TECHNICAL SPECIFICATION CHANGES

RTD BYPASS ELIMINATION

DRAFT FSAR REVISIONS

RTD BYPASS ELIMINATION

**FIGURE 5.1-1
REACTOR COOLANT SYSTEM
(M-228001(Q)-3)**

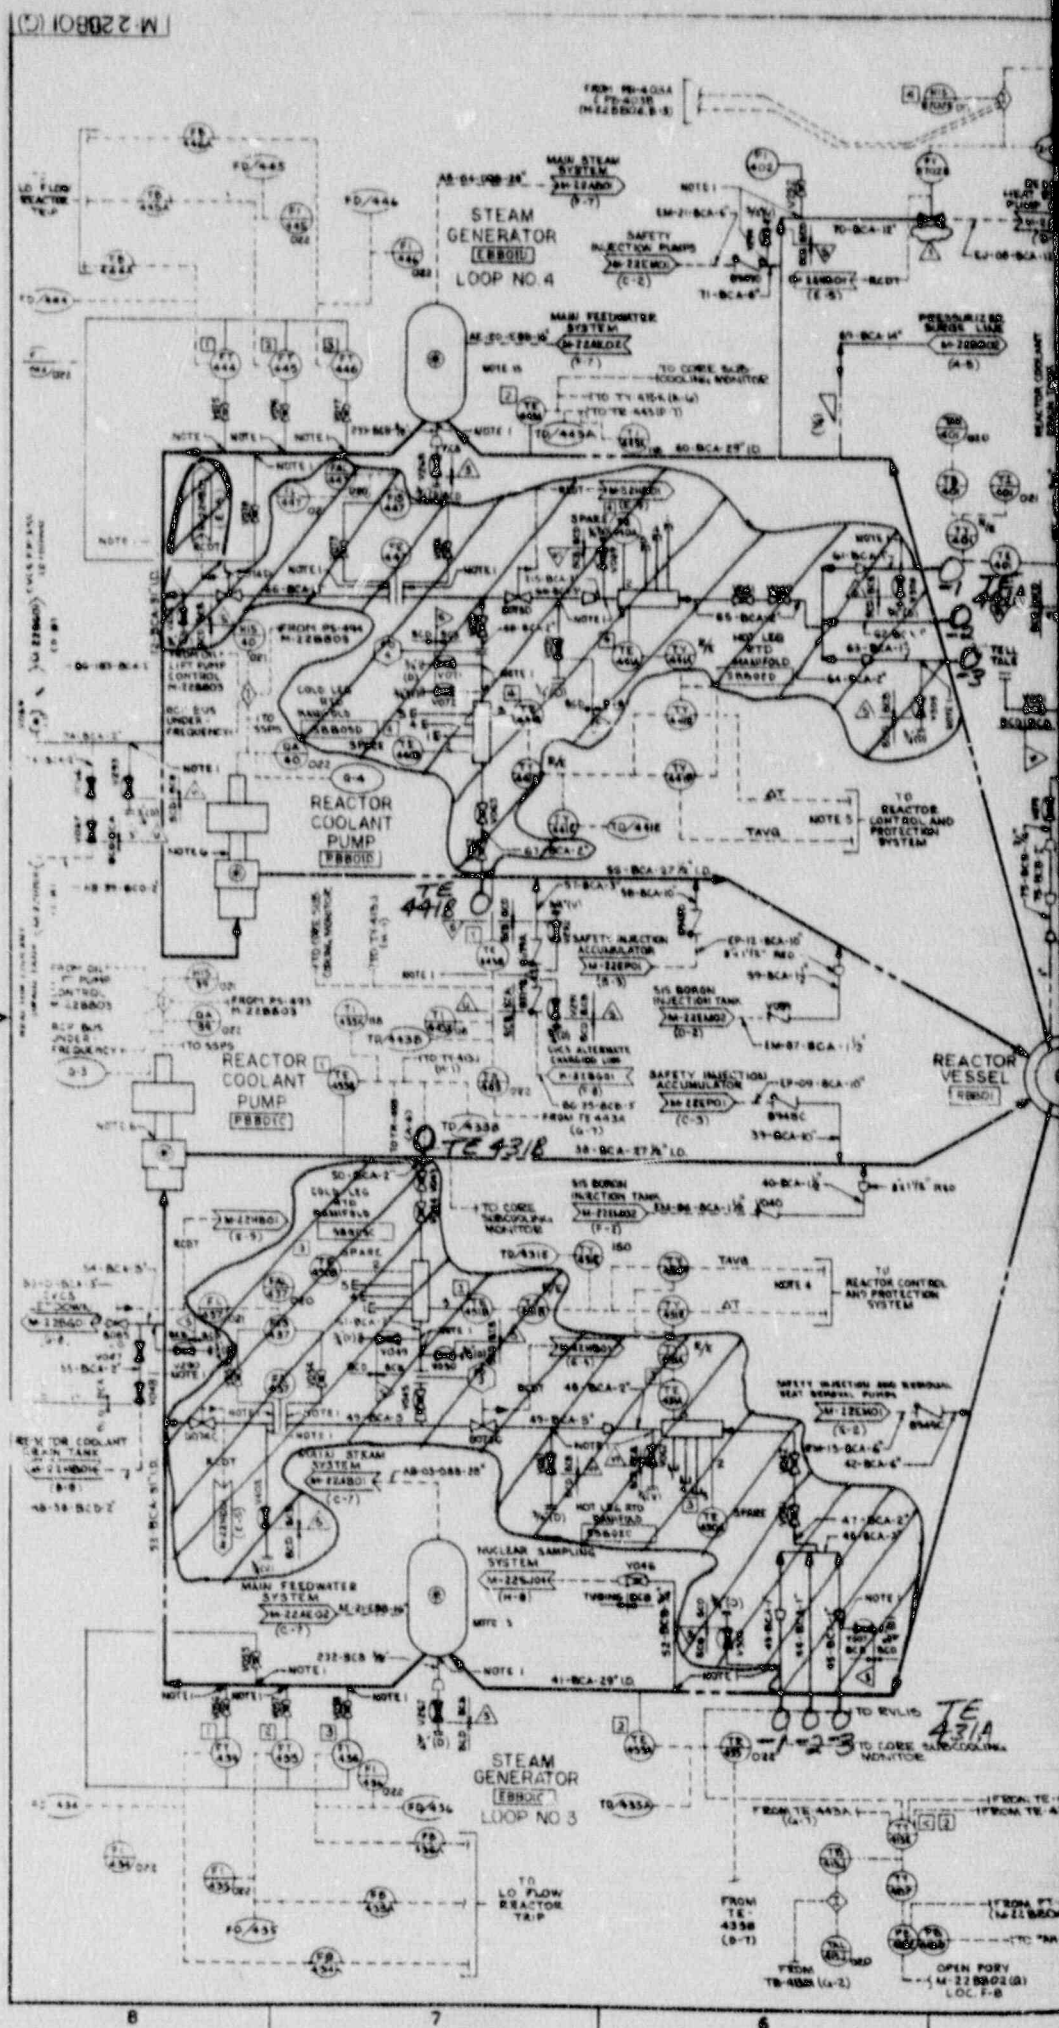
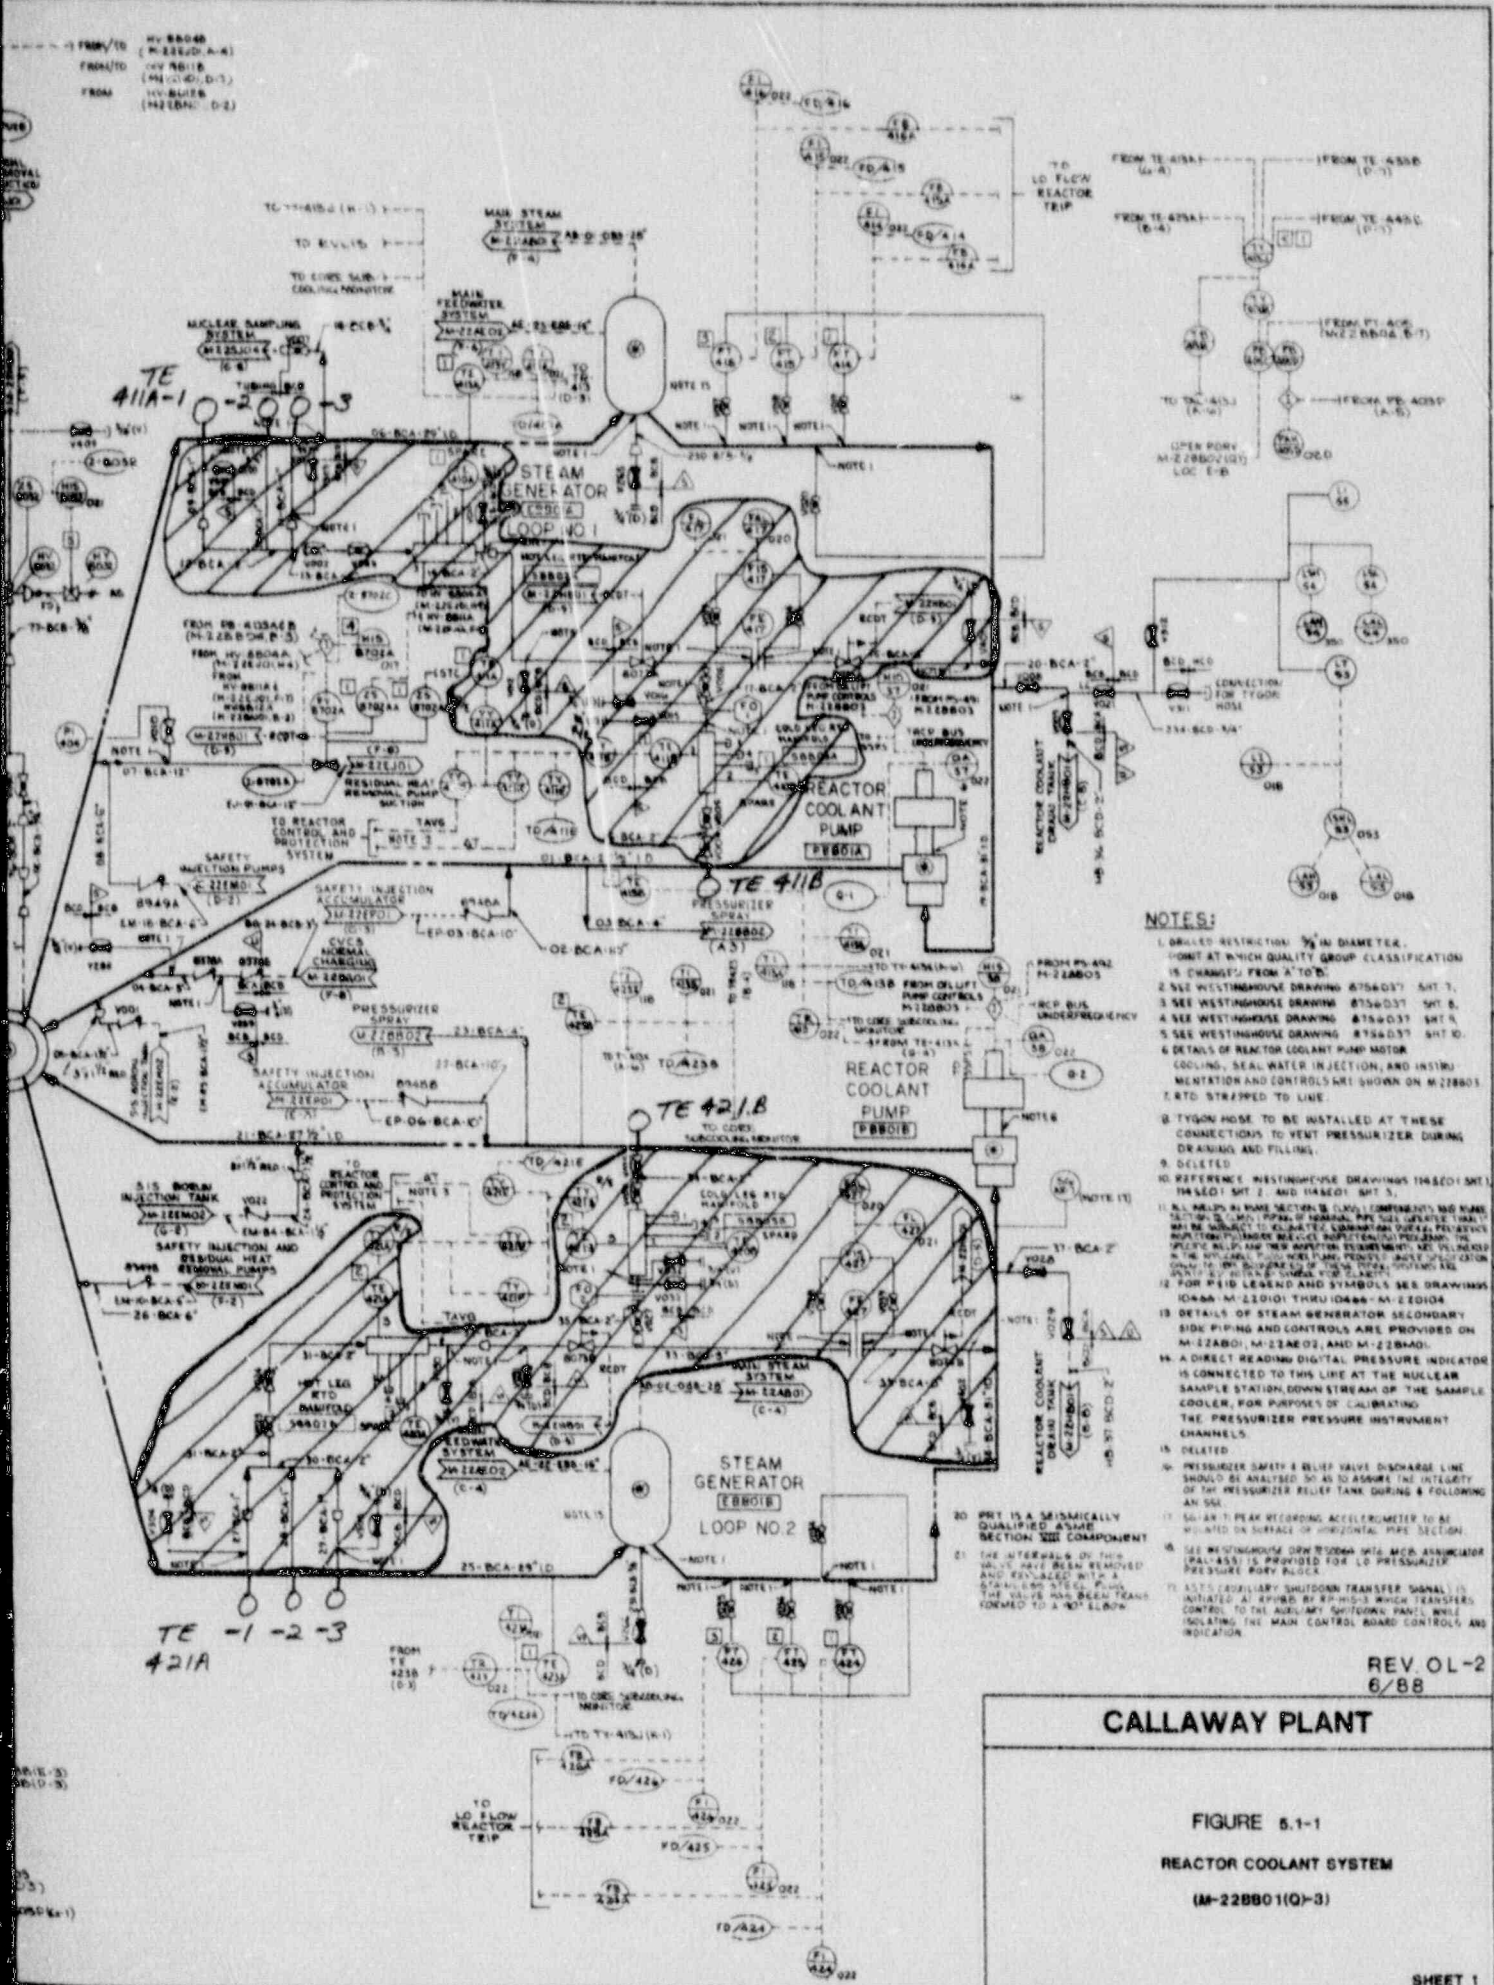
Table 3.11(B)-3	Sheets 41, 42, 43
Table 3.11(B)-7	Sheet 3
Figure 5.1-1	Sheet 1
Figure 5.1-2 and Notes (Sheets 1, 2)	
Pages 5.4-24 through 5.4-27	
Insert A	
Insert B	
Pages 7.2-13, 7.2-14, 7.2-34, 7.2-35

See CN# 8906

FIGURE 5.1-2

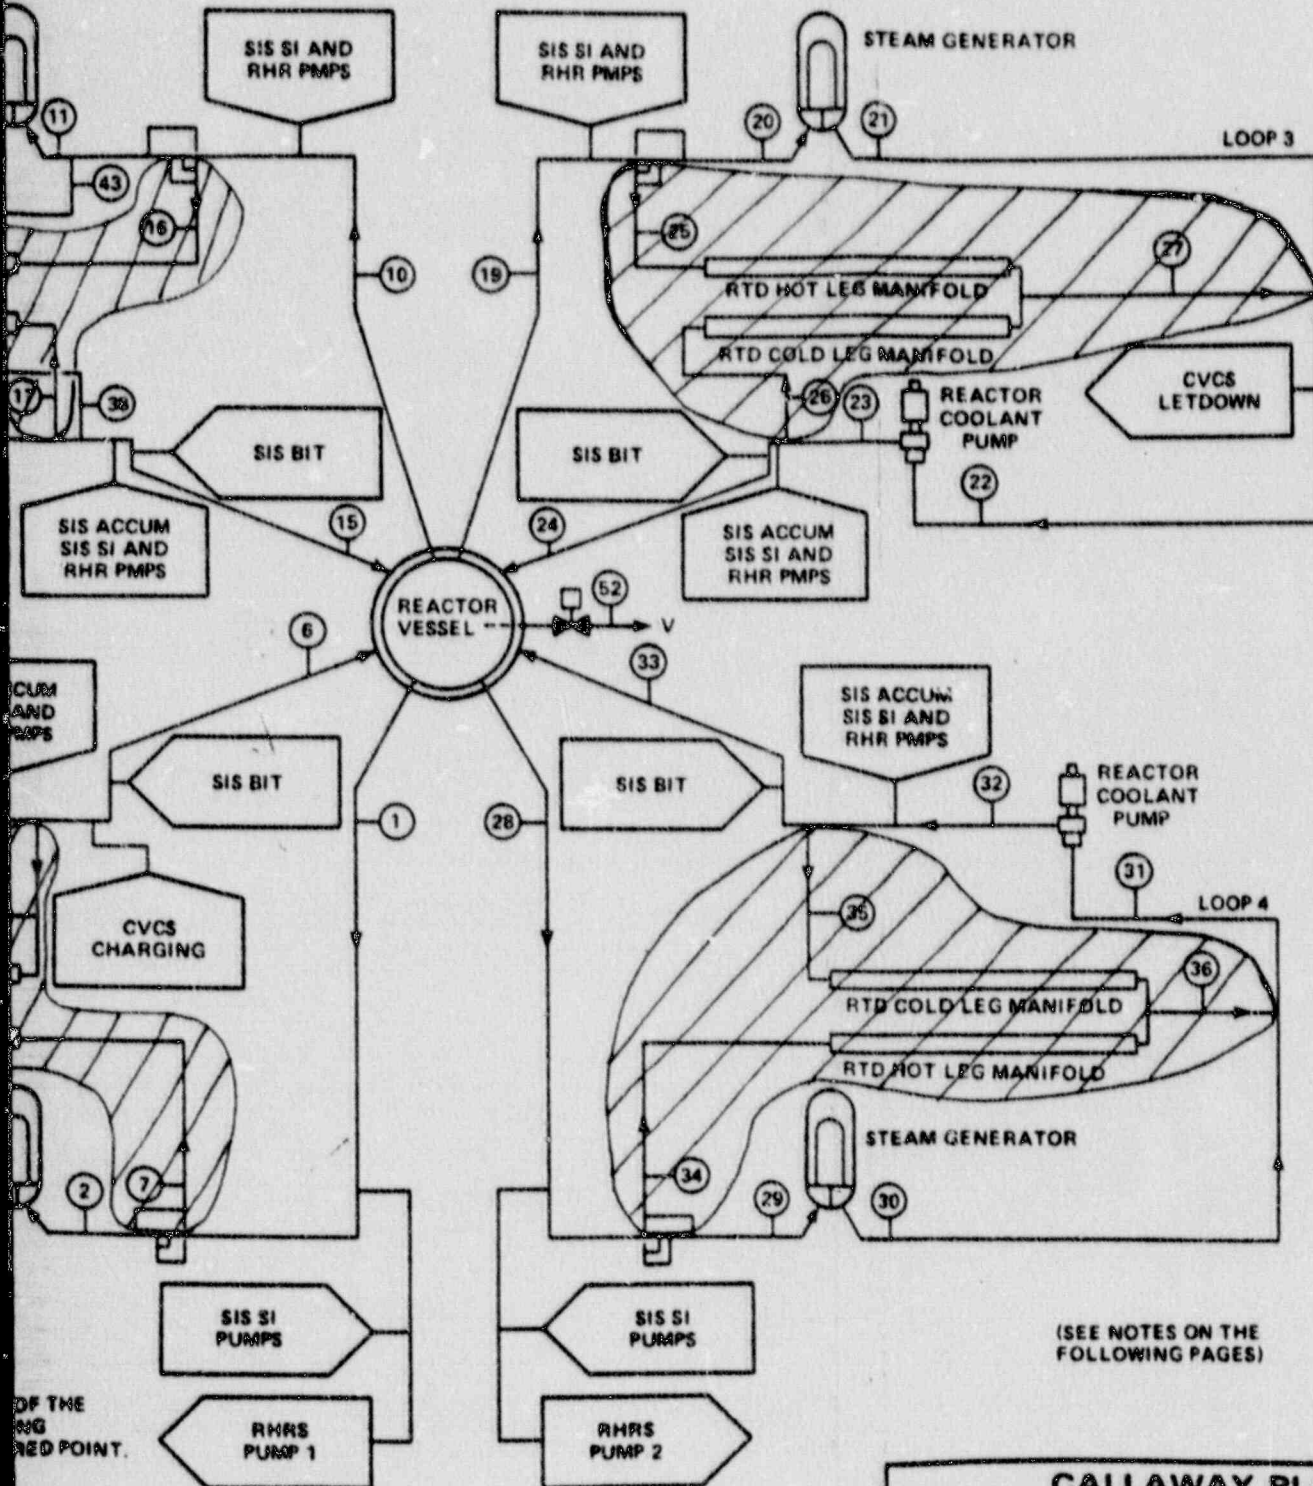
(2) $\times 10^6$.~~(3) Location point refers to the three 1" connections on the hot leg.~~~~(4) Location point refers to the 2" connection on the cold leg.~~
